## Service Manual Chassis FL4.17 AA

This Service Manual contains modified instructions and prints for the FL4.17.  
For all remaining information the Service Manual FL1.14/FL2.14/FL1.16/FL2.16/FL1.17AA should be consulted.

### Large signal panel

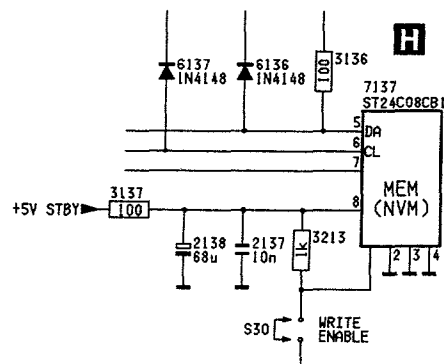
The modifications for the FL4.17 on the large signal panel with respect to the FL1.17 are:

- 2011 becomes 3.9nF	4822 122 32566
- 2035 becomes 3.9nF	4822 122 32566
- 2039 add	4822 122 31765
- 2504 becomes 270pF 2kV	4822 122 20054 for 25"
- 2505 becomes 270pF 2kV	4822 122 20054 for 25"
- 2505 becomes 330pF 2kV	4822 126 11254 for 29"
- 2520 becomes 390nF	4822 121 51527
- 3504 becomes 1.2W	4822 053 11128
- 3506 becomes 1.2W	4822 053 11128
- 3602 becomes 22k	4822 100 11213
- 3603 becomes 10k	4822 051 10103
- 3633 becomes 150k	4822 051 10154

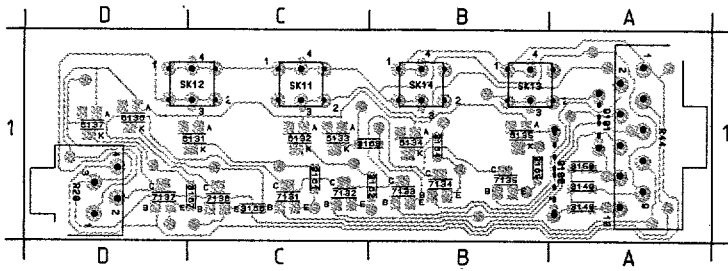
In addition the EROM protection has also been added to the small signal panel, this consists of the following modifications (see figure):

- S30 add pin strip 3P	4822 265 31009
- 3213 add 1kΩ	4822 051 10103
- 9228 add	
- 4135 remove	
- 7137 becomes ST24C08CB1	4822 209 32283

S30 = OPEN: READ ONLY  
SERVICE SETTINGS  
S30 = CLOSE: READ/WRITE  
SERVICE SETTINGS
